Hurricane Planning Commission Meeting Agenda

June 12, 2025
6:00 PM

Agenda Date:	06/12/2025 - Planning Commission
Application Number:	ZC25-14
Type of Application:	Zone Change Amendment
Action Type:	Legislative
Applicant:	Michael and Aimee Carnell
Agent:	
Request:	Approval of a Zone Change from R1-15 to General Commercial (GC).
Location:	2085 S 700 W
Zoning:	Single Family Residential R1-15
General Plan Map:	Single Family
Recommendation:	Recommend approval to the City Council.
Report Prepared by:	Fred Resch III

ZONE CHANGE FOR:
DIXIE POWER

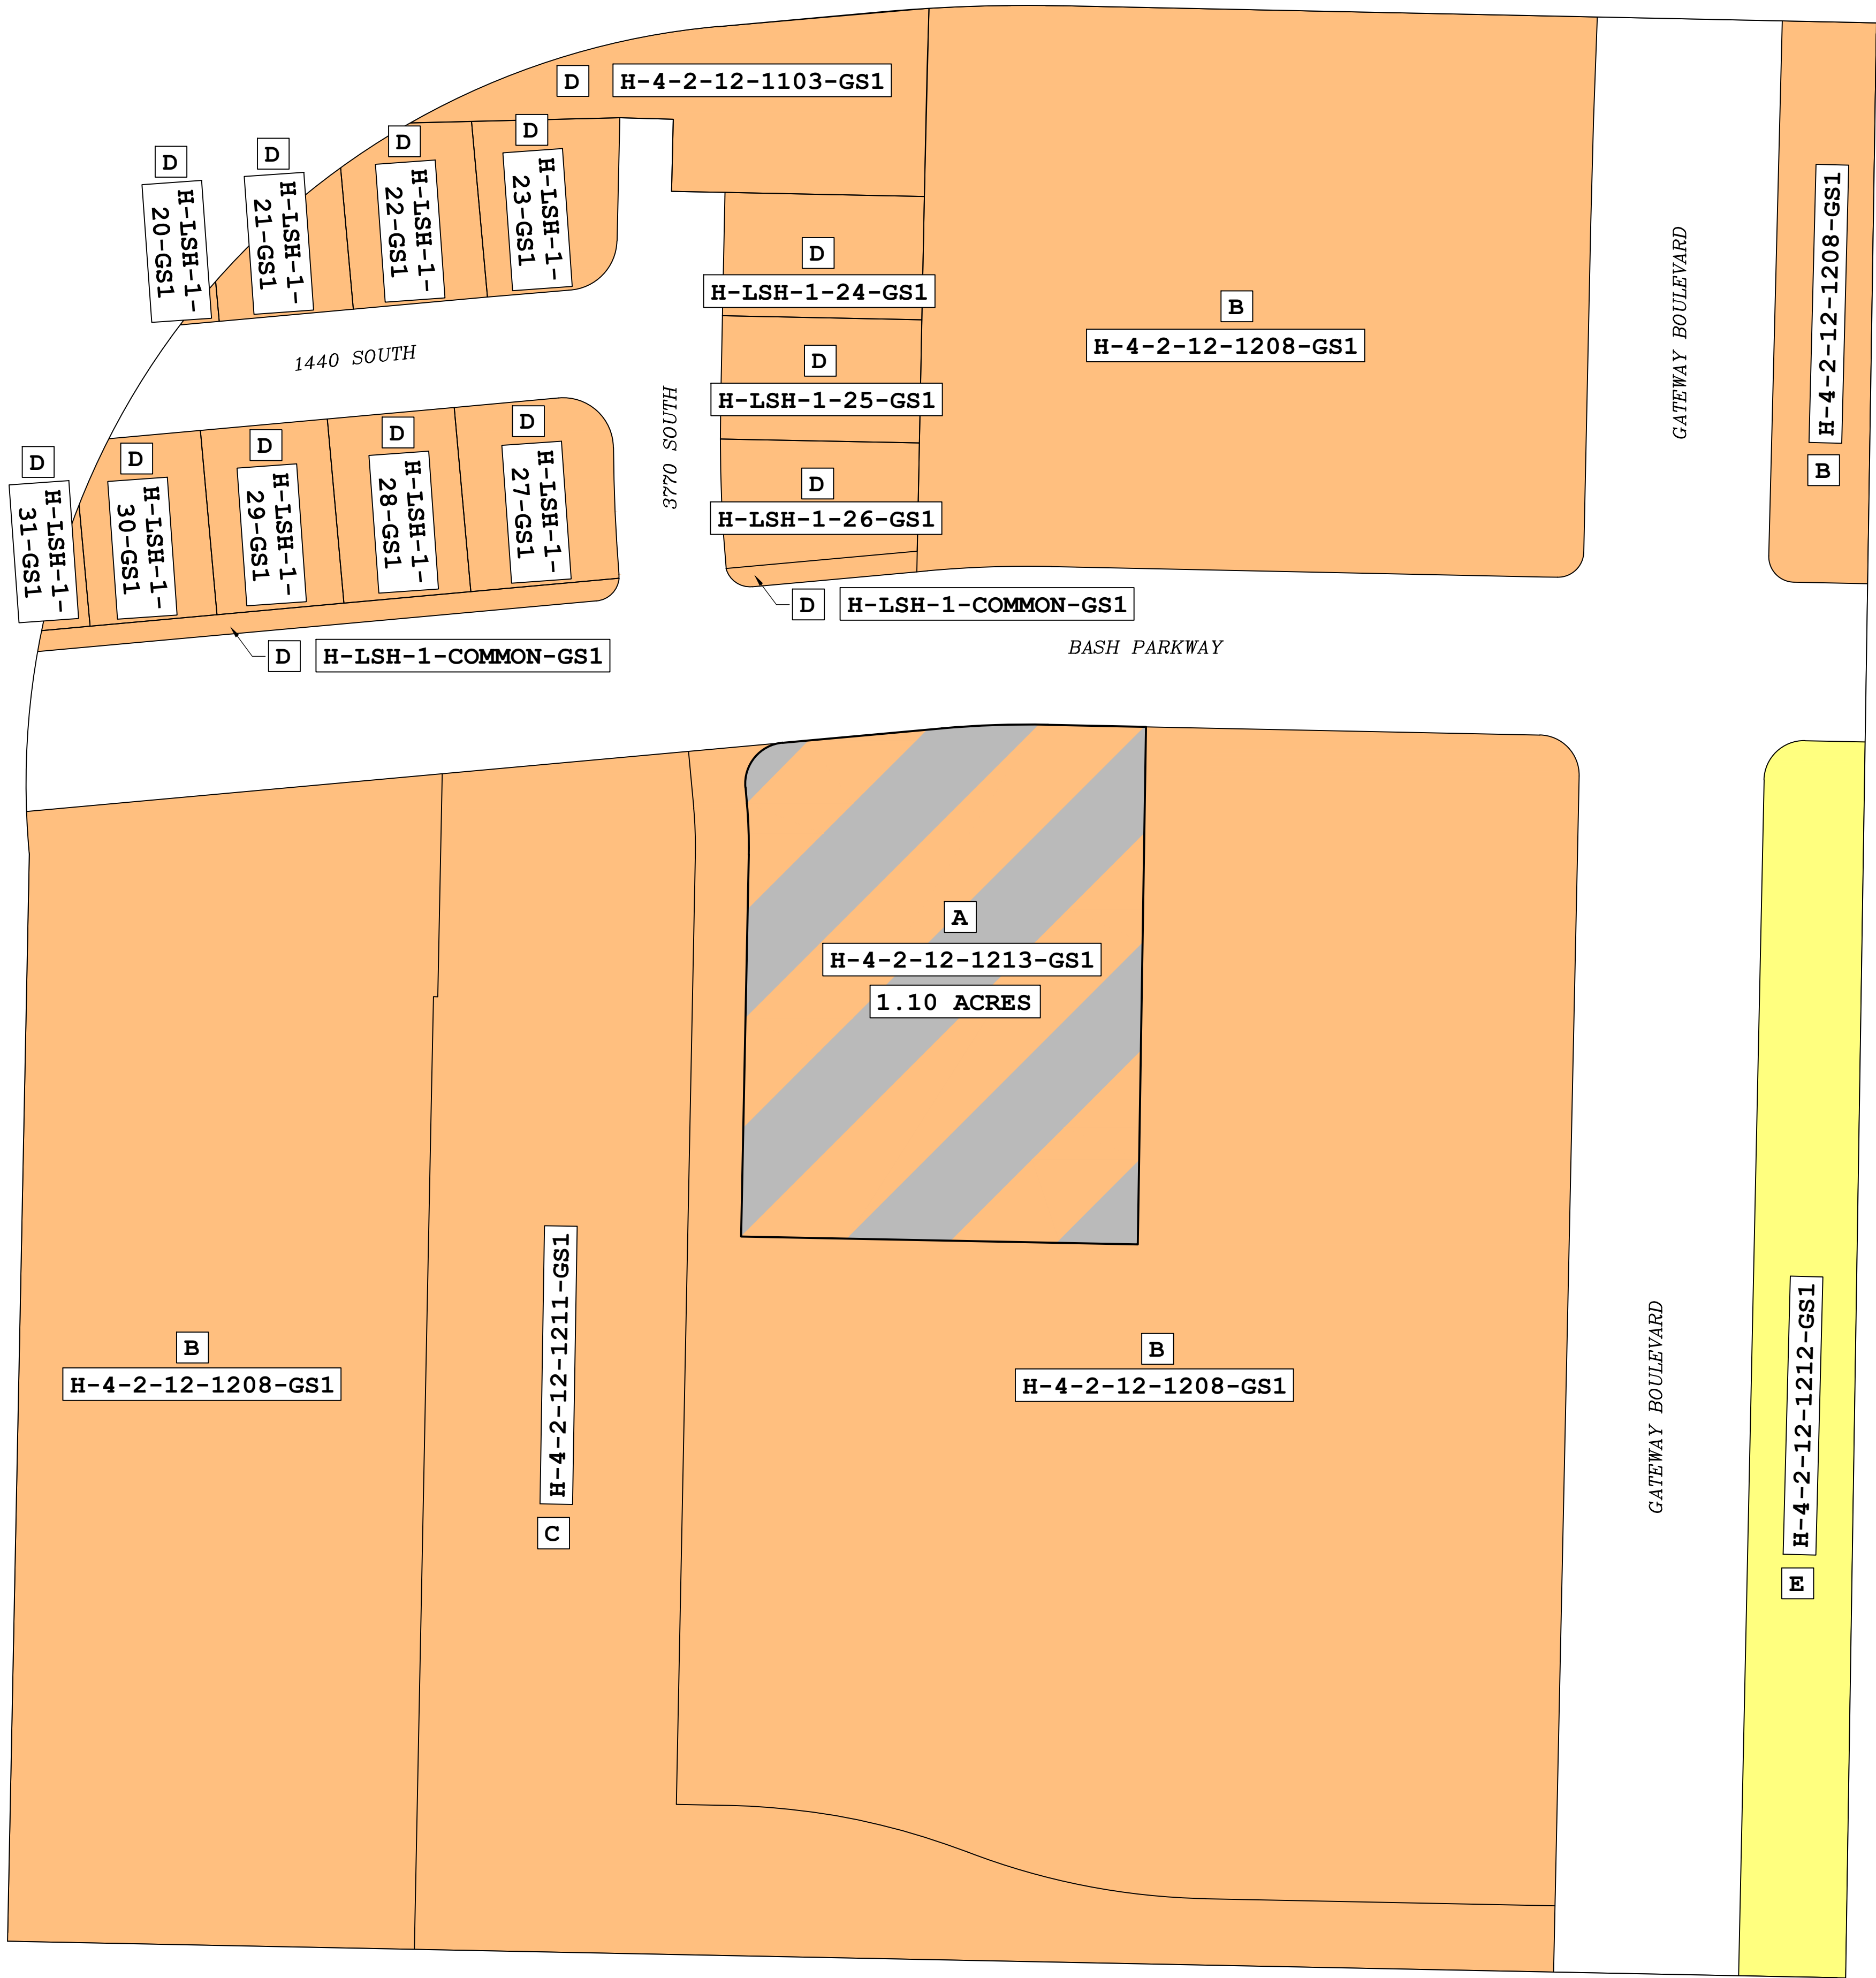
1. The applicant will need to do a preliminary and final site plan for the substation when they are ready to proceed with construction.

Recommendation: The Planning Commission should review the proposed zone change based on the applicable standards within the Hurricane City Code and consider any public comments received at the public hearing for the item and make a recommendation to the City Council. Staff recommends approval.

PECAN VALLEY PROJECT
CURRENT ZONING
LOCATED IN HURRICANE, UTAH

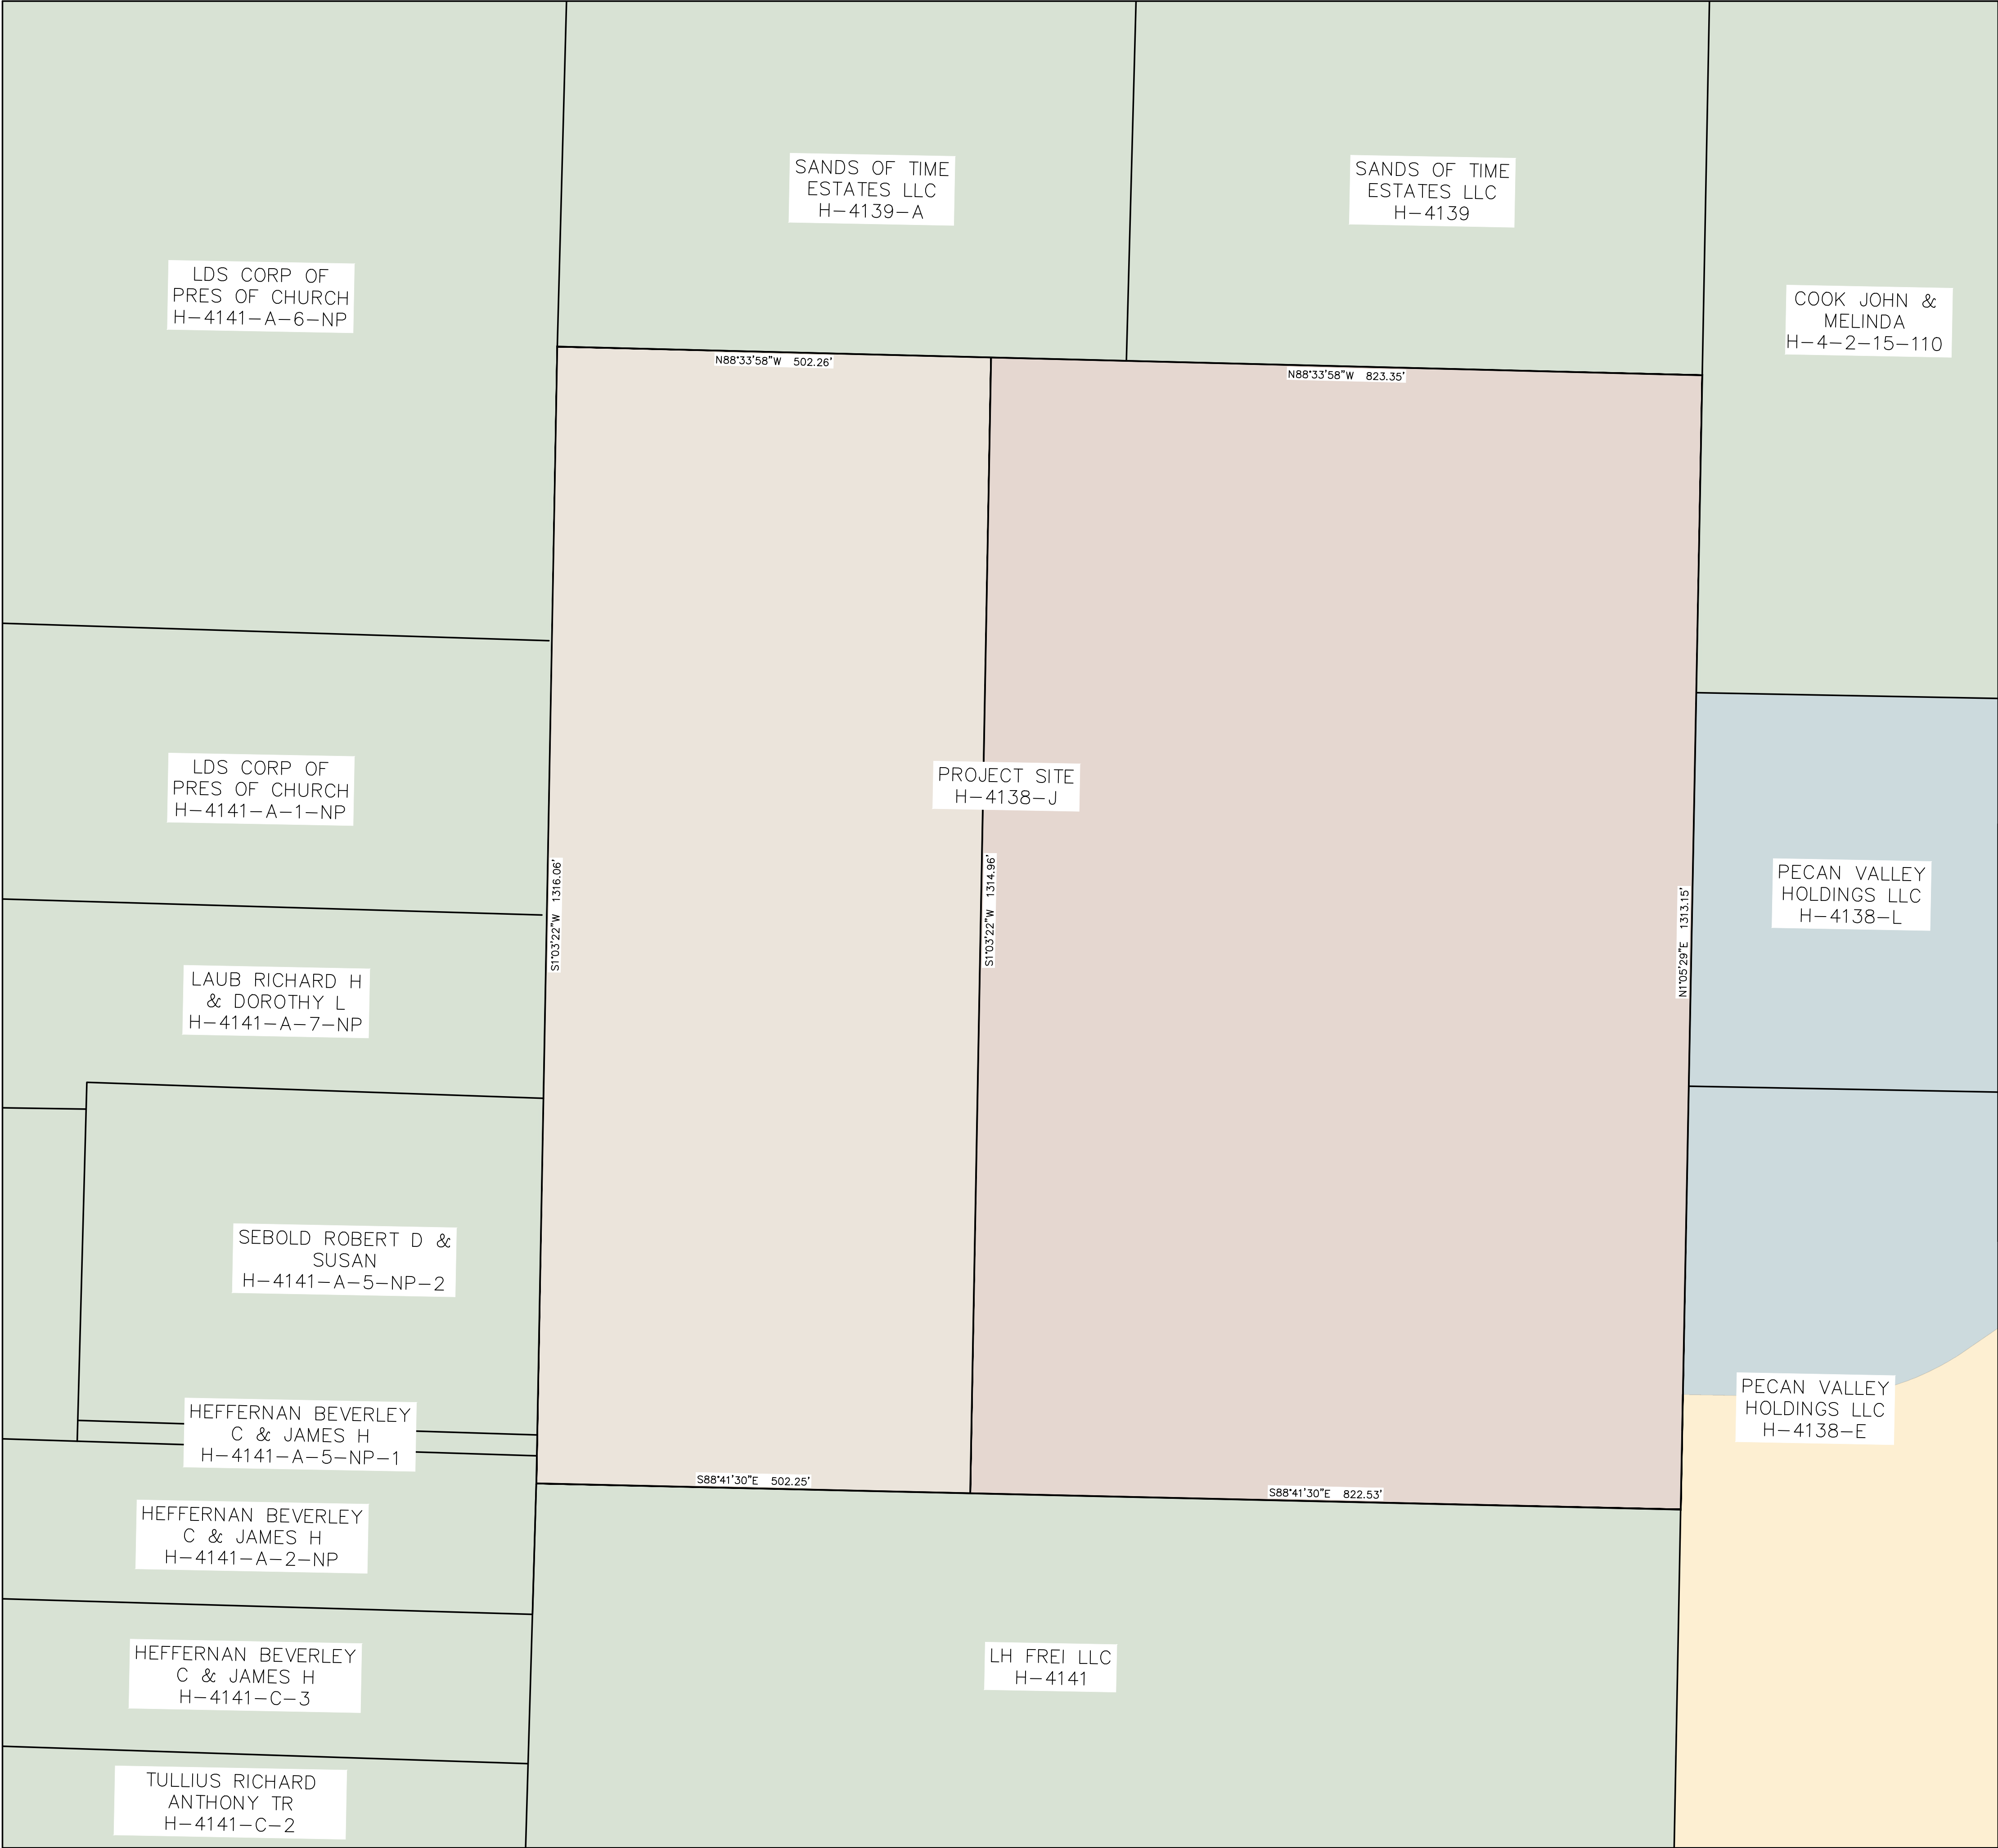
Other Considerations: Given that this property is adjacent to land designated as Rural Residential on the Future Land Use Map, which allows densities up to RA-0.5, it may be more appropriate to reverse the proposed layout of the R1-6 and R1-8 zones. Currently, the proposed R1-6 zoning is located along the western portion of the site, which borders the area designated for Rural Residential use. Shifting the R1-8 zoning to the west and the R1-6 zoning to the interior or east side of the parcel would help create a more appropriate transition in density and character between existing and planned development patterns. The Planning Commission has the discretion to recommend that the City Council consider a revised zoning layout or approve a less intense zoning designation that would create more compatible development with the surrounding properties and better consistency with the long-term planning objectives of the General Plan.
